ADDENDUM NO. 3

**RE: NCDAC NC Correctional Institution for Women
Air Conditioning Installation
SCO ID#: 22-24913-02A
NCDAC Central Engineering Job Order # 4290**

DATE: September 12, 2023

2 SIMPLIFIED PURGE MODE MANUAL SWITCH INTERFACE MODEL (SINGLE CELL B, TYPICAL FOR EACH PACU NOT TO SCALE

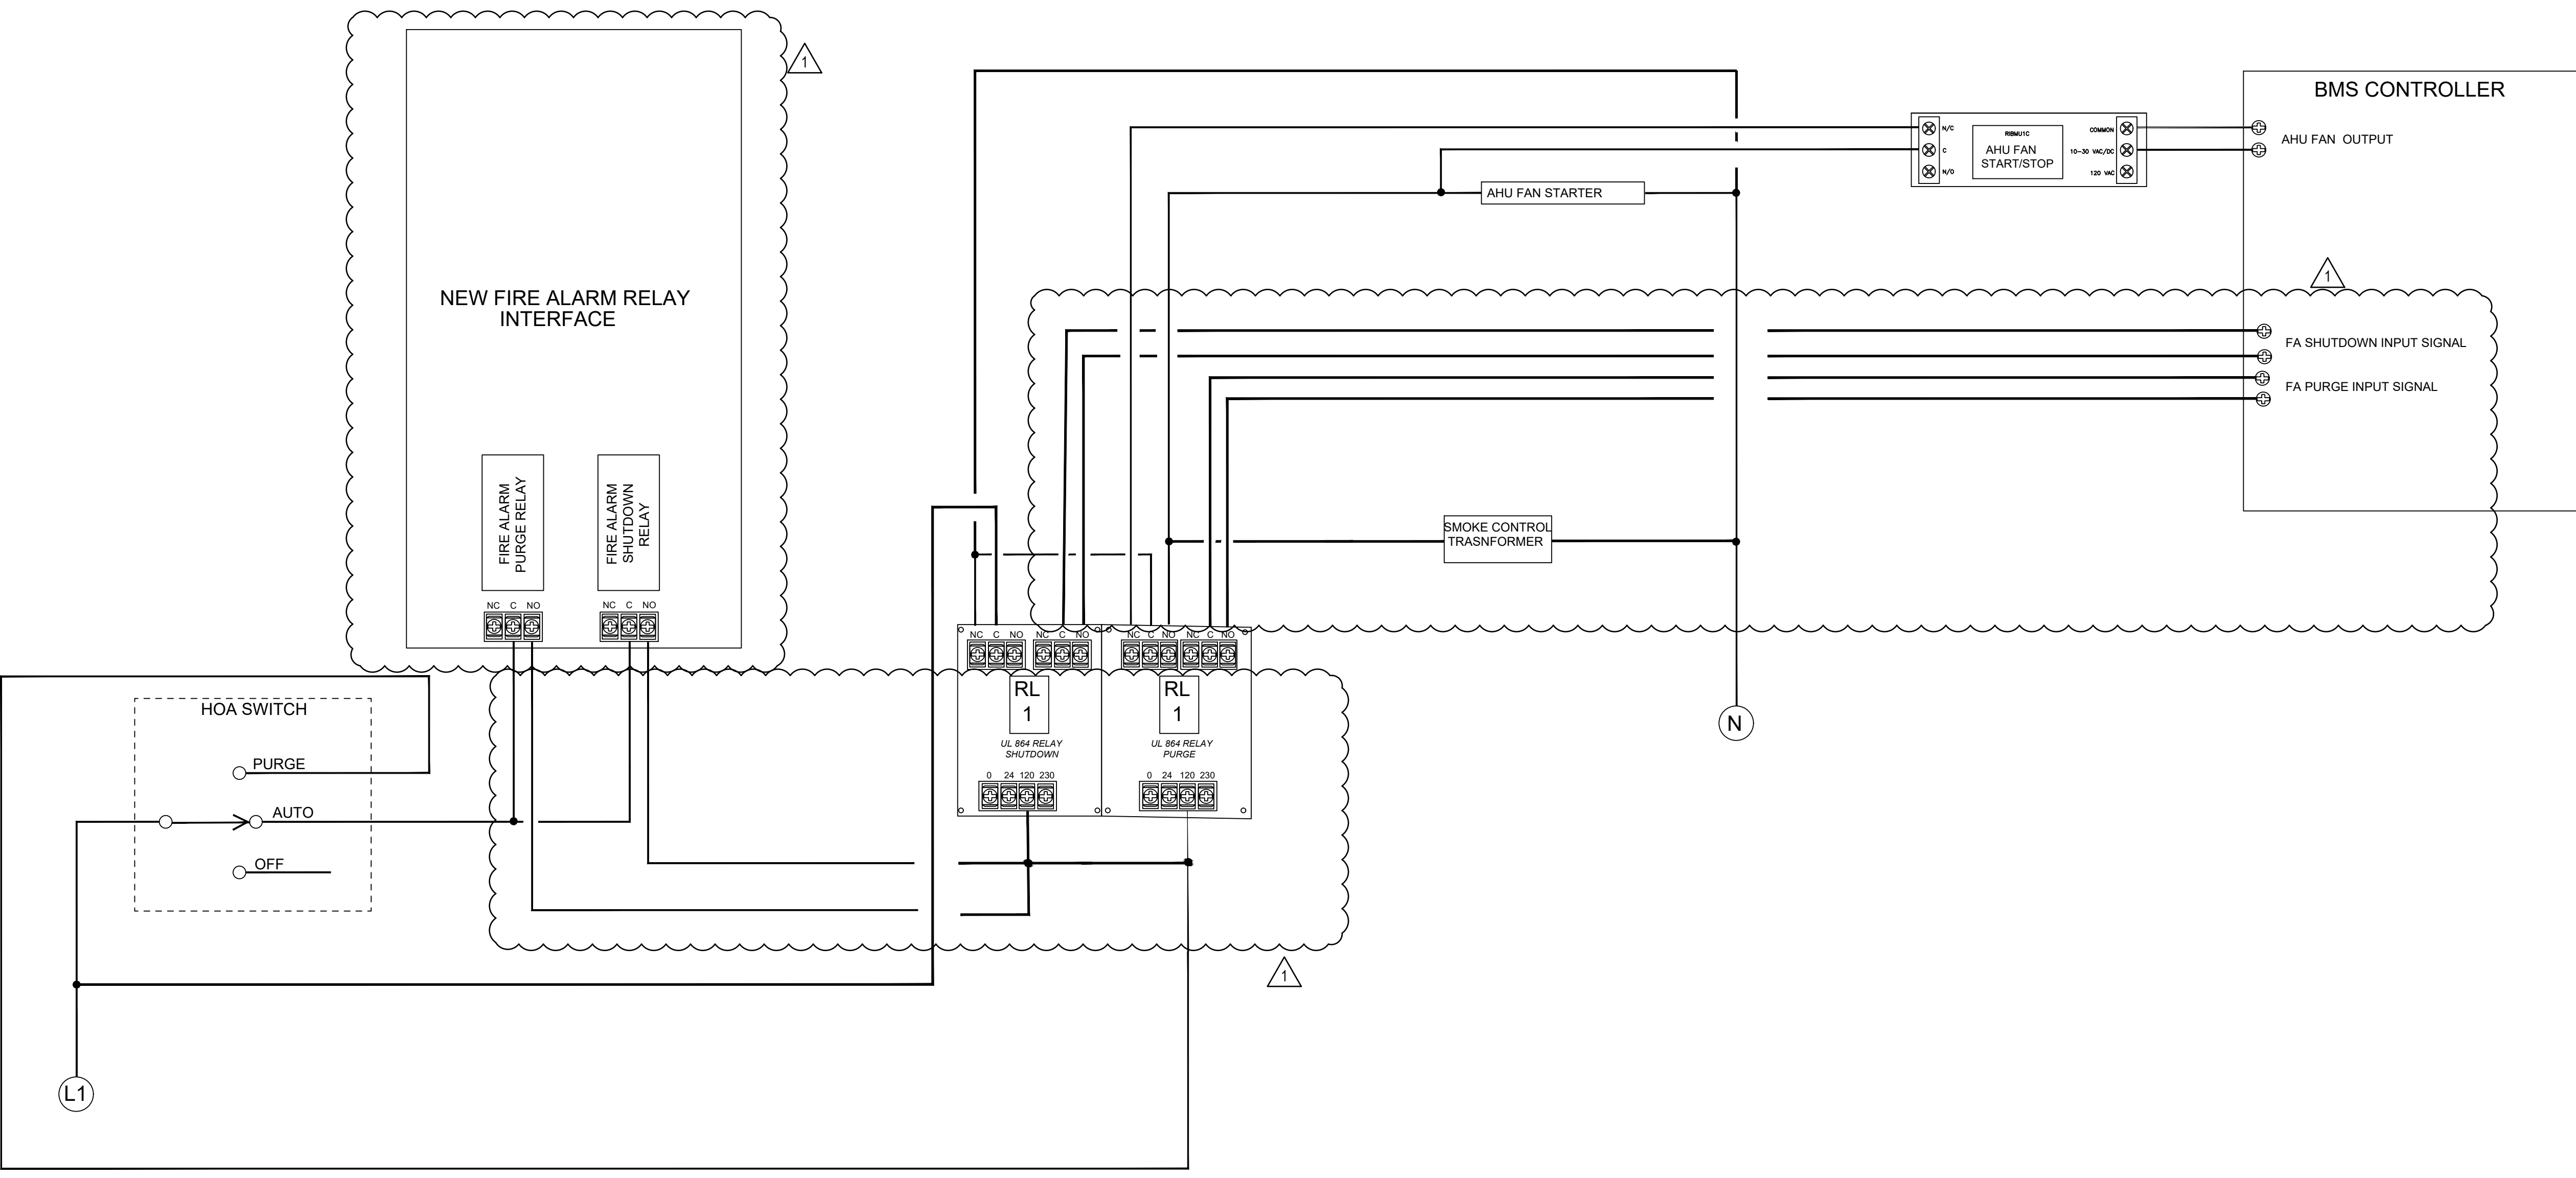
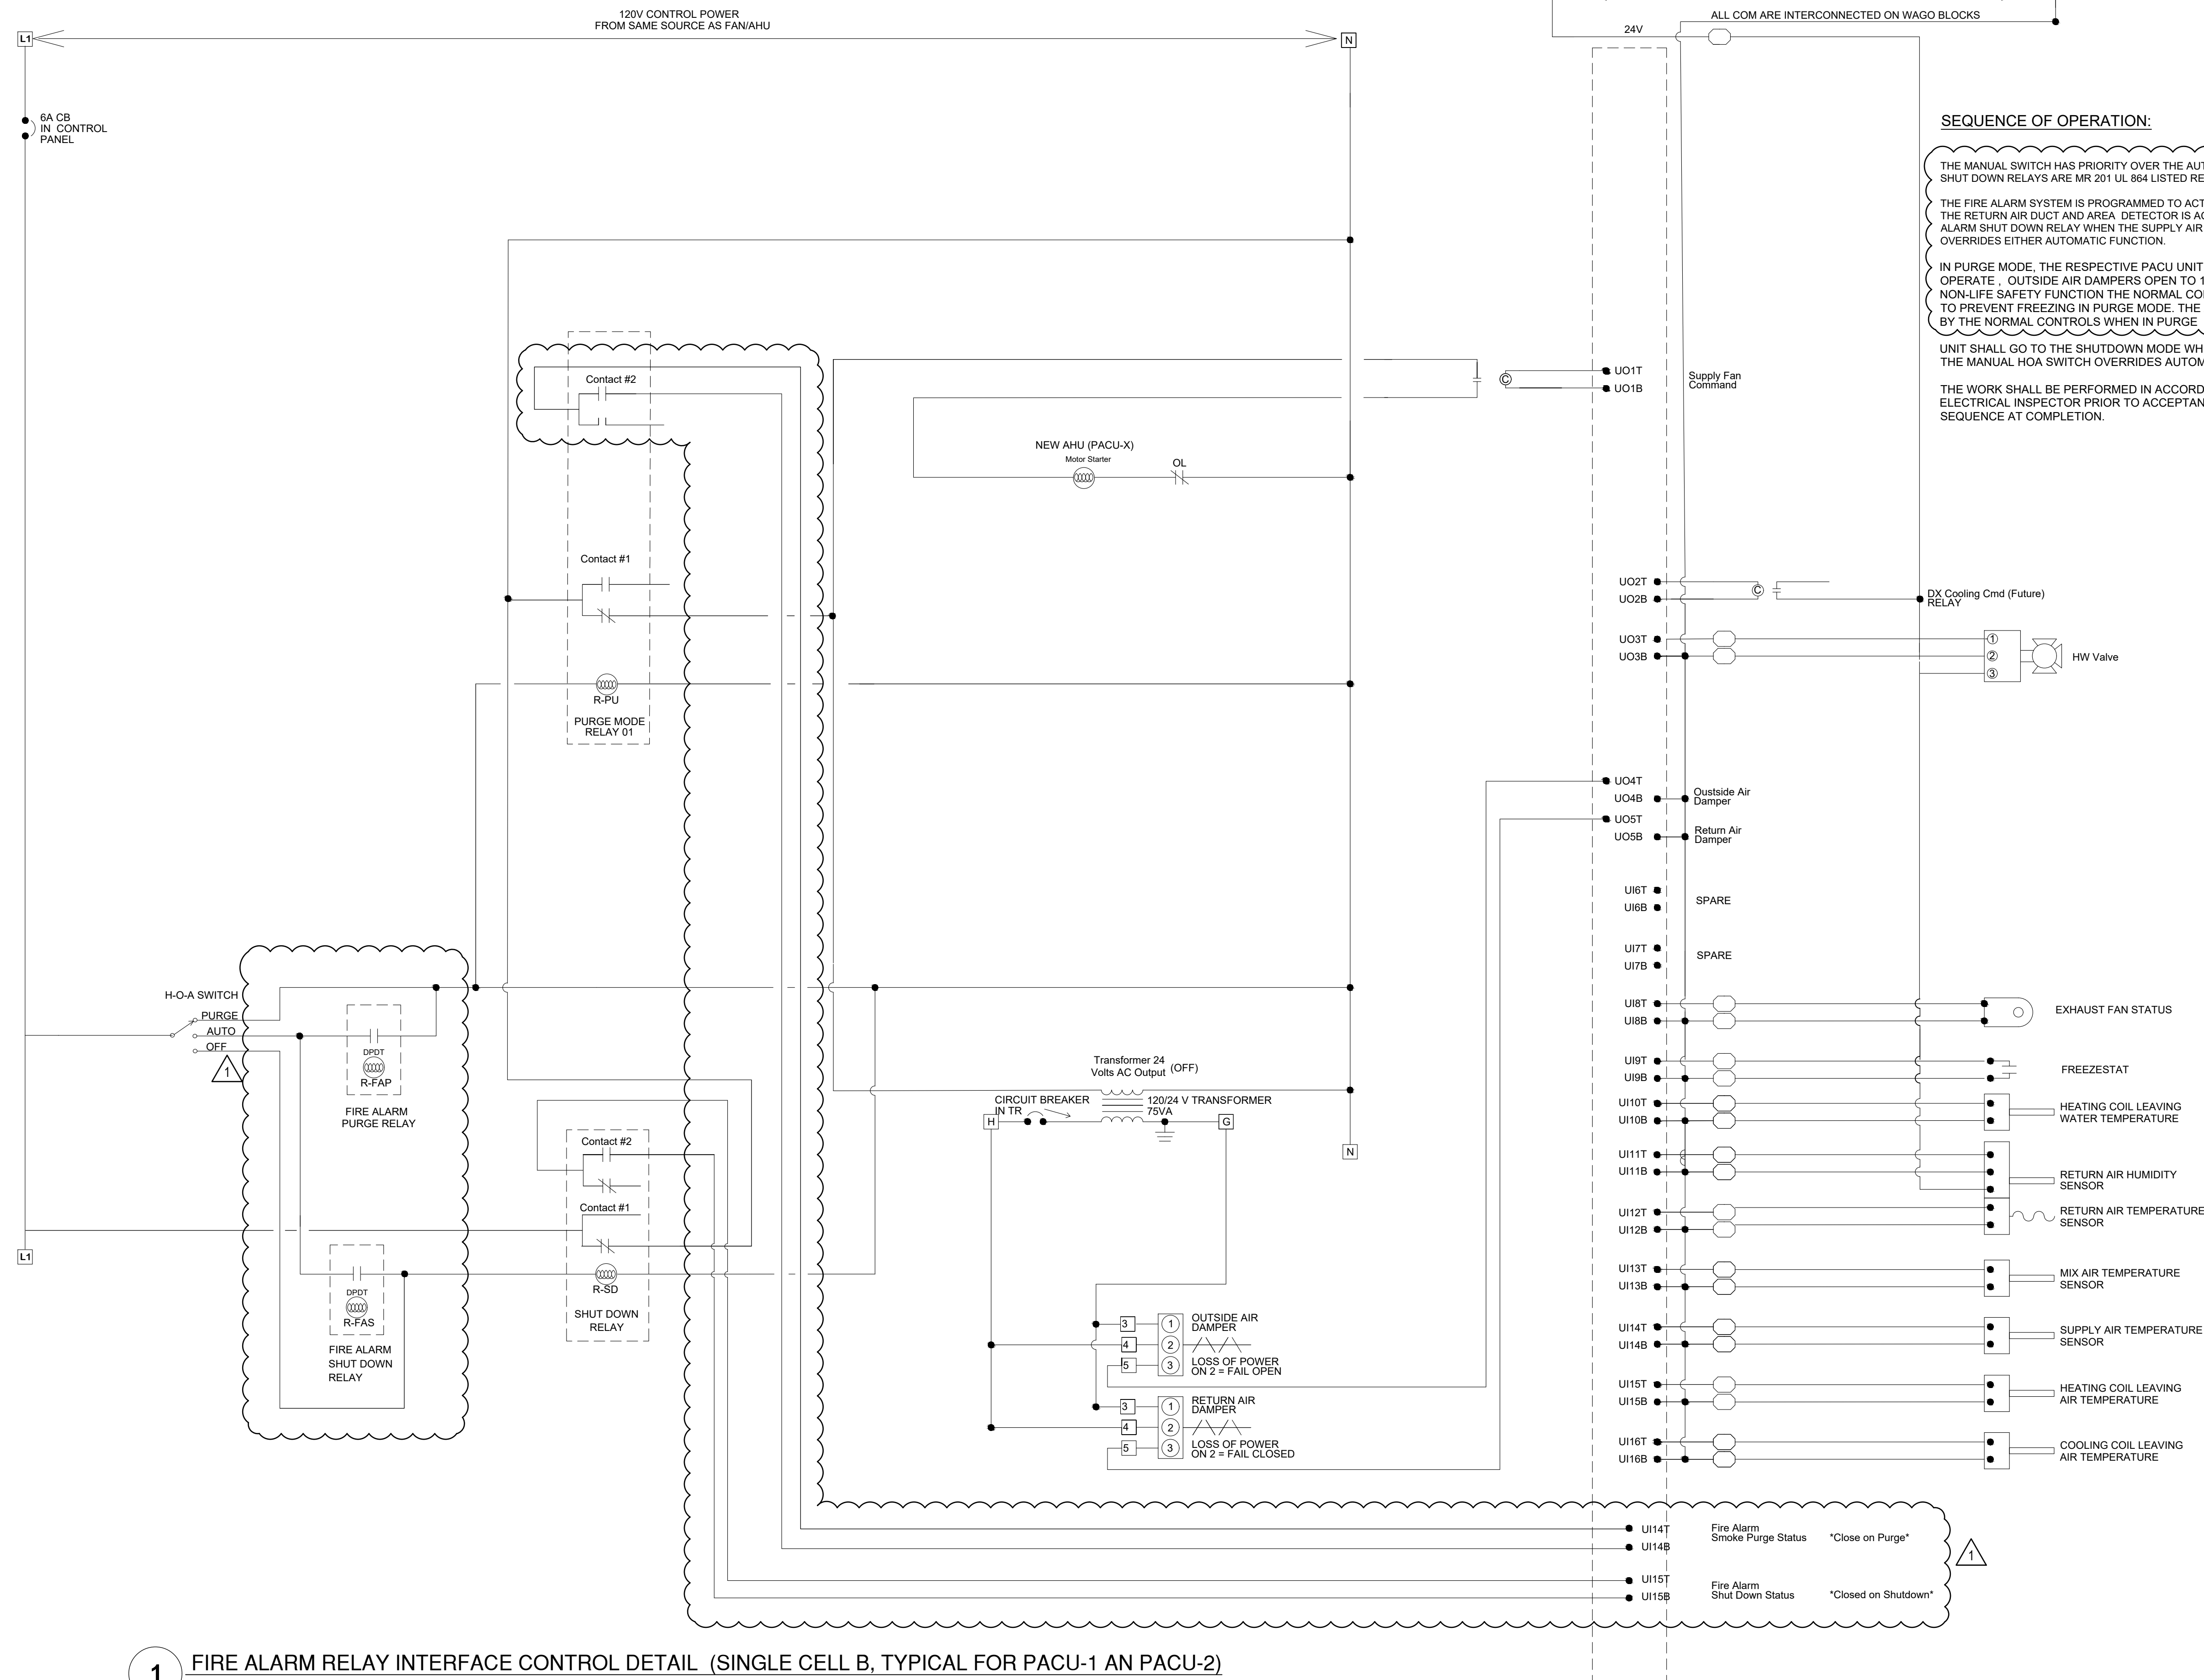
17. Sheet M609: See revisions on attached sheet.
18. Sheet M610: See revisions on attached sheet.
19. Sheet M700: See revisions on attached sheet.
20. Sheet E131: See revisions on attached sheet.

1 SINGLE CELL B - ELECTRICAL NEW WORK
E141 Scale: 1/8" = 1'-0"

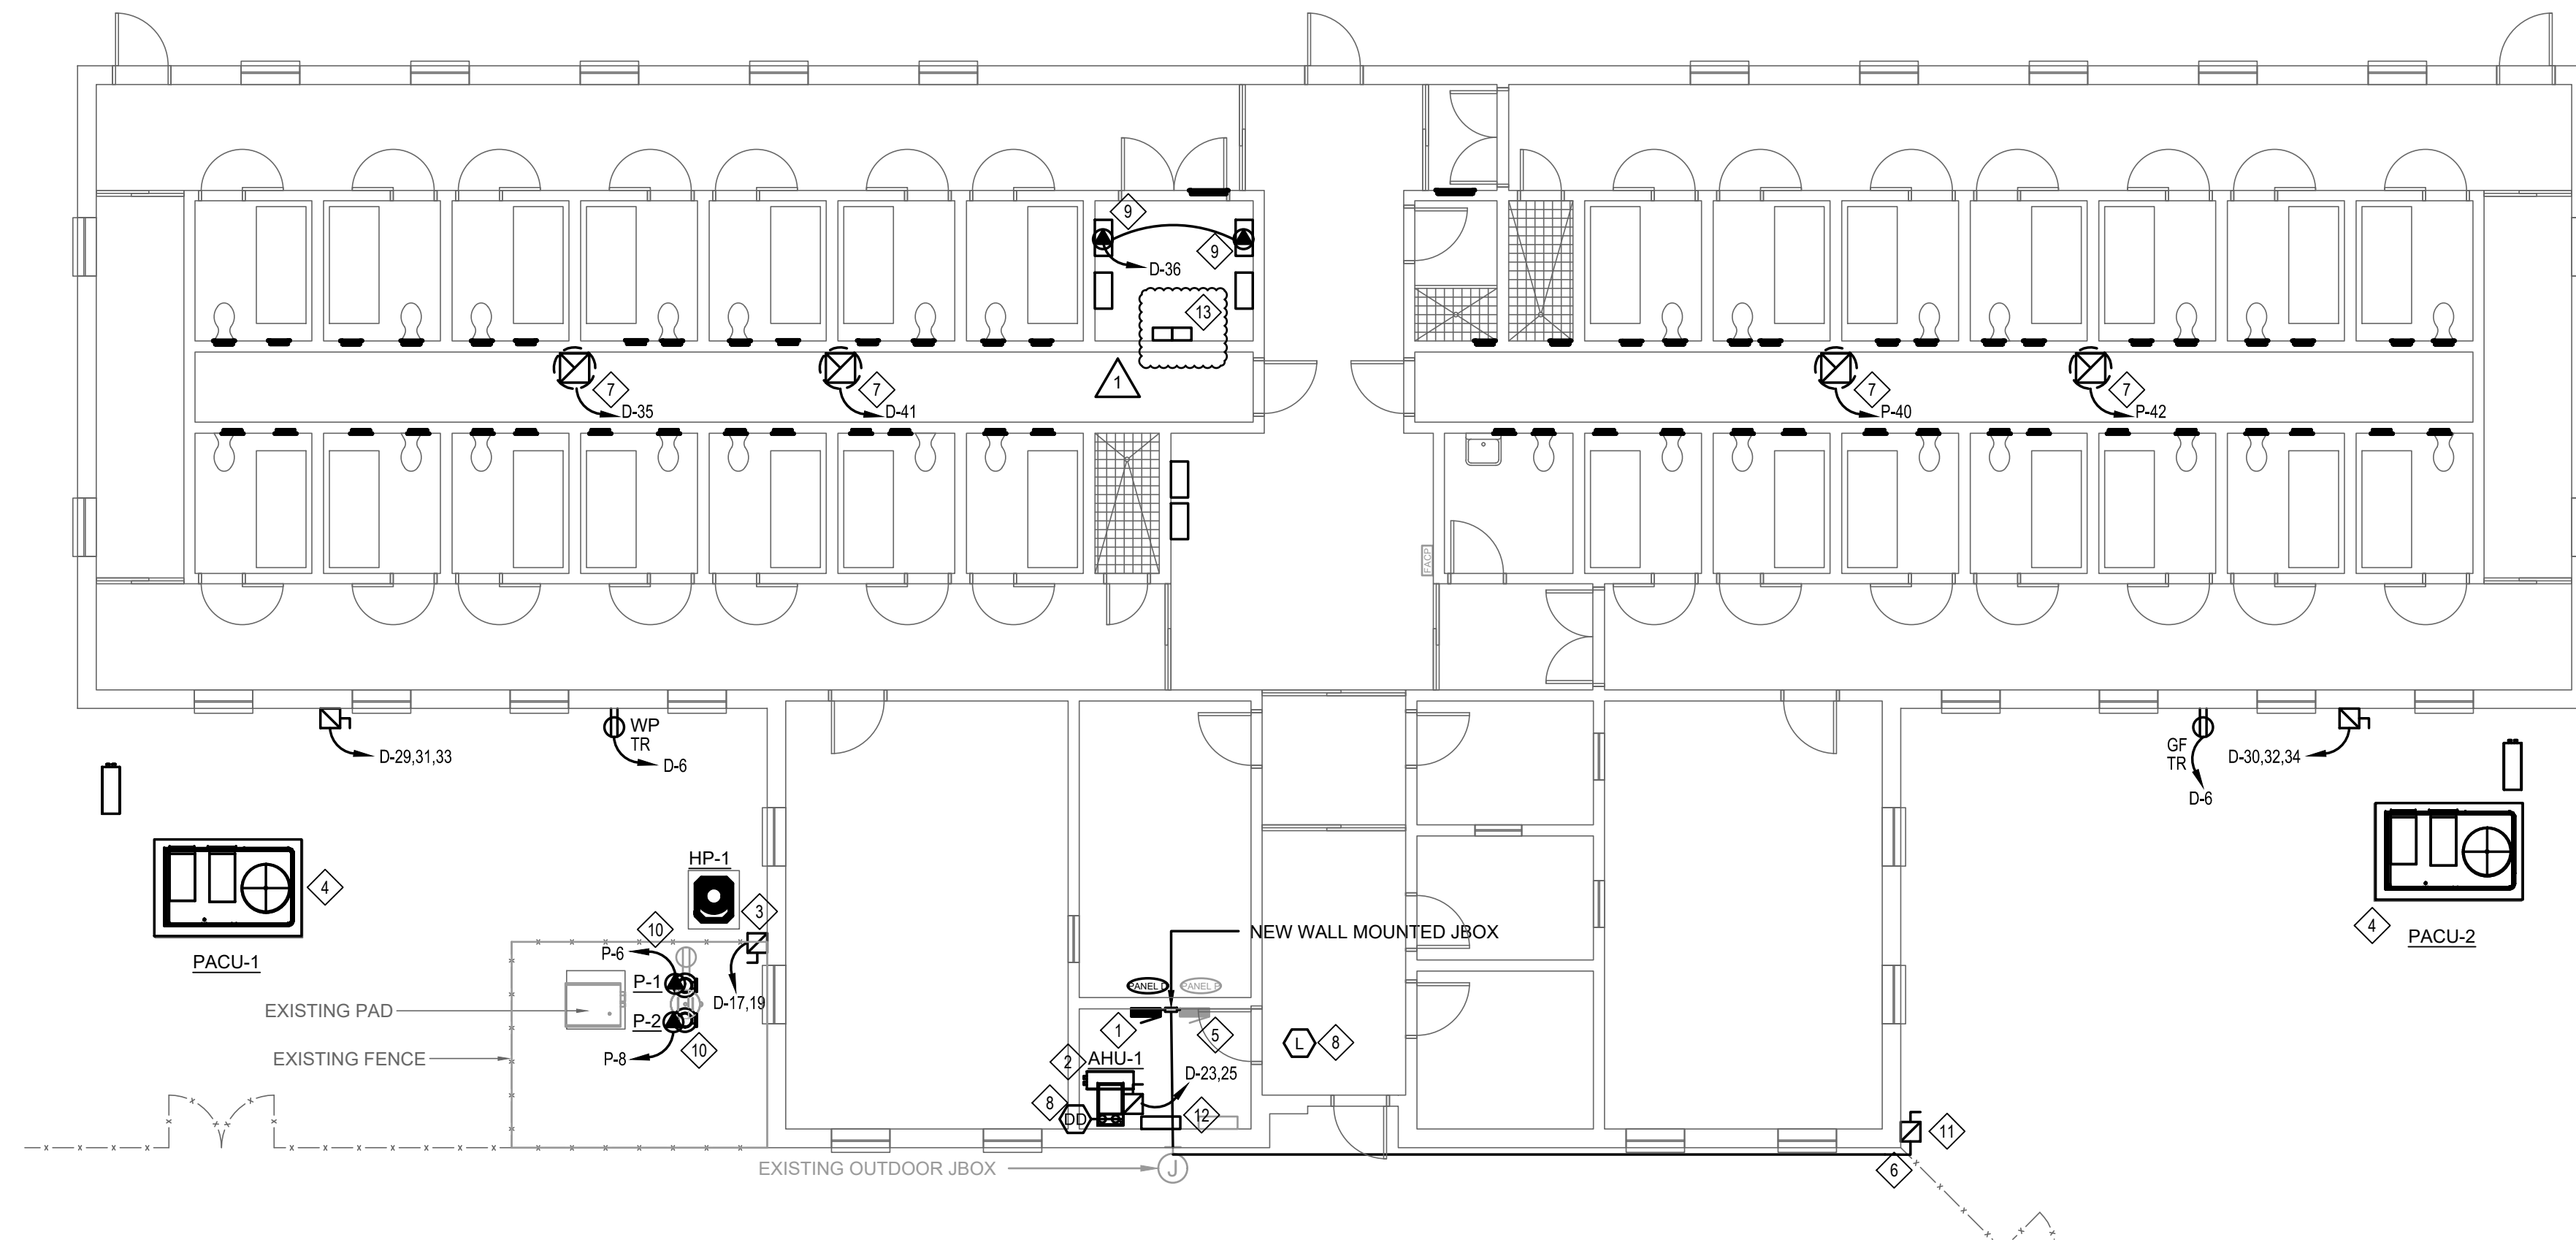
21. Sheet E141: See revisions on attached sheet.
22. Sheet E602: See revisions on attached sheet.

13. FA CONTRACTOR SHALL PROVIDE A NEW FIRE ALARM RELAY INTERFACE FOR EACH OF THE NEW PACKAGED AIR HANDLING UNITS SHUTDOWN AND PURGE RELAYS. SEE E602 AND MECHANICAL CONTROL SHEETS FOR MORE DETAILS.
